Planning Committee 29th July 2025

SUMMARY OF LATE COMMENTS/REPORT UPDATE

APPLICATION: 25/00415/FL

<u>Late Representation: Application 25/00415/FL – Retrospective Application for InPost Parcel Locker at Unit 5, Ankerbold Road, Tupton Committee Date: 29 July 2025</u>

Figure 14 clearly evidences the danger to highway safety.

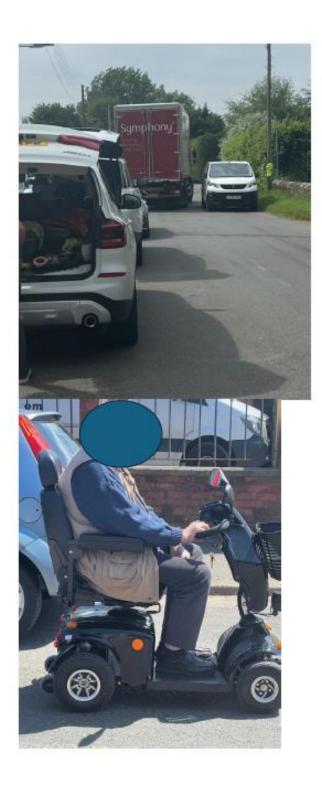
The officer report relies heavily on theoretical assessments and two limited site visits, one of which occurred on a Wednesday afternoon when nearby businesses were closed. This does not reflect the actual usage patterns of the site.

- Vehicles routinely parking within the carriageway, reducing the road to a single lane.
- Cars stopping abruptly in unsafe positions to access the locker.
- Drivers using residents' private driveways on the opposite side of the road as parking and turning, causing intrusion and danger at all times of the day and night.
- Mobility scooters and pedestrians forced onto the live carriageway due to blocked pavements.

Officers note the comments and photographs submitted. Having reviewed the submitted representations, Officers retain the view that the development that this application seeks to retain represents an acceptable form of development within the defined Settlement Development Limits of Tupton. In the context of the wider site's functional commercial appearance, the parcel locker would represent an acceptable visual addition to the area. Whilst Officers accept that the proposed development would result in increased levels of activity within the vicinity of the site (and some of the above photographs may be illustrative of this), it is not considered that such activity would result in overriding significant harm to the existing residential amenity levels of properties in the locality. Moreover, for the reasons set out in the Officer Committee Report, Officers consider that the development which this application seeks to retain would not result in any unacceptable impacts on highway safety in the vicinity of the site. This Officer view is supported by the consultation response from DCC Highways Officers, in which no objections were raised from a highway safety perspective.
